**City of Glendale  
Community Development Department  
Design Review Staff Report – Multi-Family**

<b>Meeting/Decision Date:</b> December 18, 2019	<b>Address:</b> 1115 Sonora Avenue
<b>Review Authority:</b> <input type="checkbox"/> DRB <input checked="" type="checkbox"/> ADR <input type="checkbox"/> HPC <input type="checkbox"/> CC	<b>APN:</b> 5623-009-012
<b>Case Number:</b> PDR 1916717	<b>Applicant:</b> Art Barsegian
<b>Prepared By:</b> Danny Manasserian	<b>Owner:</b> Vardan Zeynalyan

The applicant is proposing to demolish 1,028 SF of an existing 1,528 SF front house and add 1,153 SF to the existing one-story house (built in 1925), located on an 8,350 SF lot with two residential units. No changes are proposed to the existing two-story unit at the rear with an attached garage or to the existing detached garage, serving the front unit. The property is located in the R-2250 (Medium Density Residential) zone.

SHEET NO:  
A-1

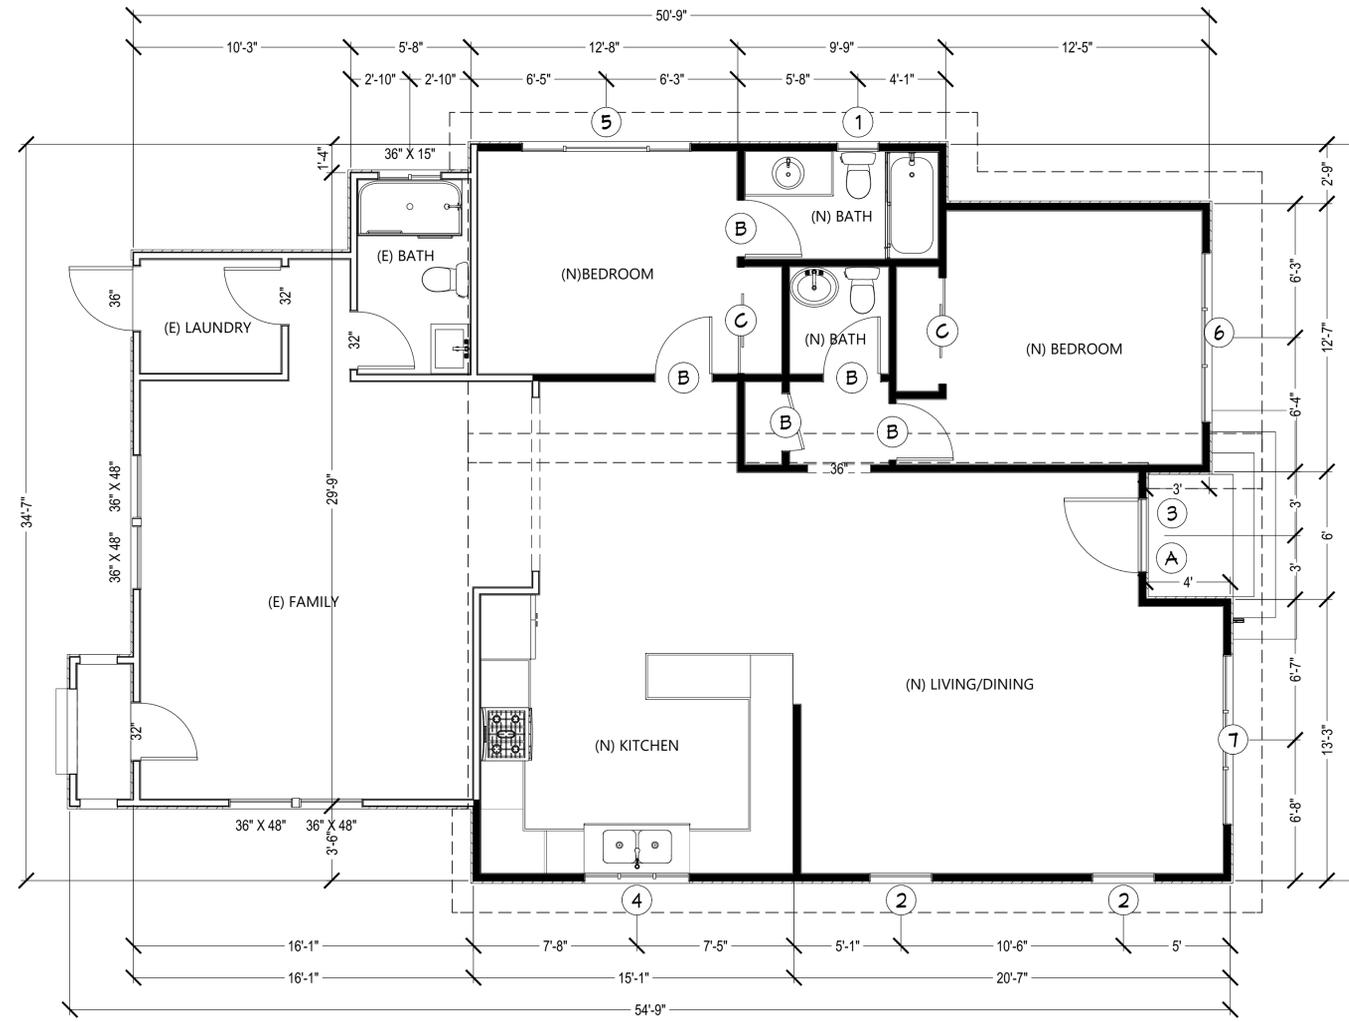
A designated trash area is not clearly depicted on the site plan. A condition is added requesting to clearly show a proposed location for trash areas for both units.

- Access to both garages for the front and rear unit will be from the existing driveway located on the west side of the property.
- The applicant has not provided a location for the trash enclosures on the site plan. A condition is added requesting to clearly show a proposed location for trash areas for both units.

1. Clearly show proposed location for trash areas for both units.
2. Provide a window schedule and vertical window section to ensure all windows are nail-in to match the unit at the rear.
